Date: October 20, 2003

To: T10 Committee (SCSI)

From: George Penokie (IBM/Tivoli)

Subject: End-to-End Data Protection

Figure 1 — CRC generator bit order

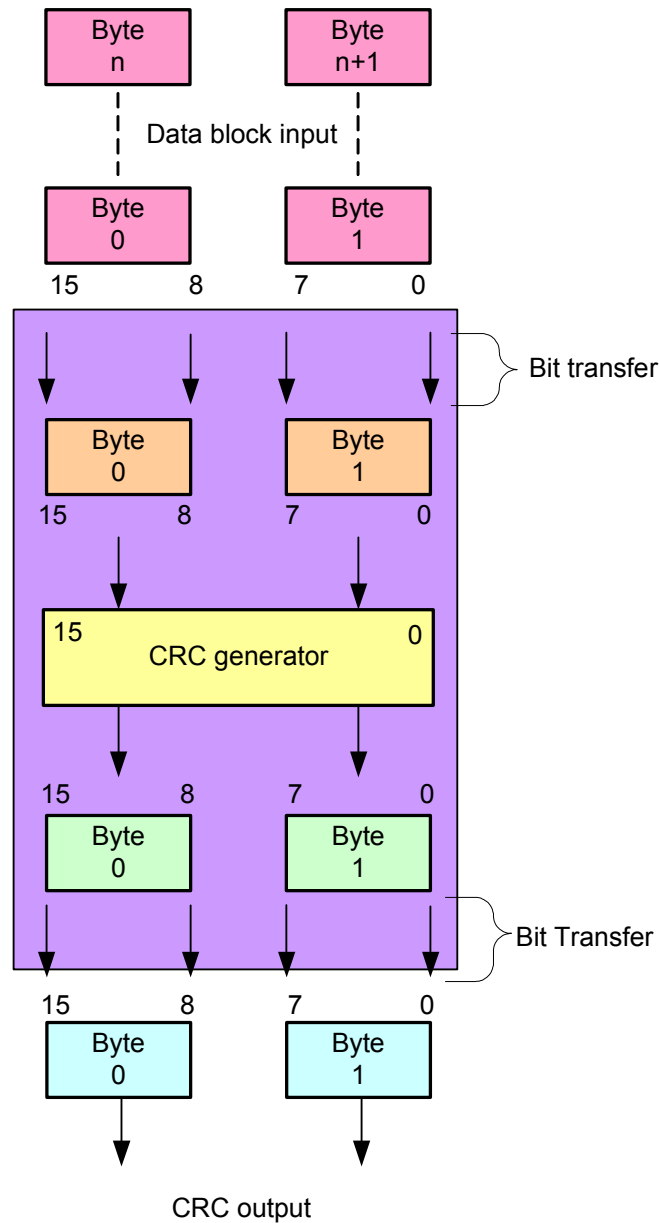
Editor's Note 2: Received the following comment: Figure 1 the "Bit transfer" portions are unnecessary. Get rid of the purple, orange, and green boxes and just feed into the yellow CRC generator.
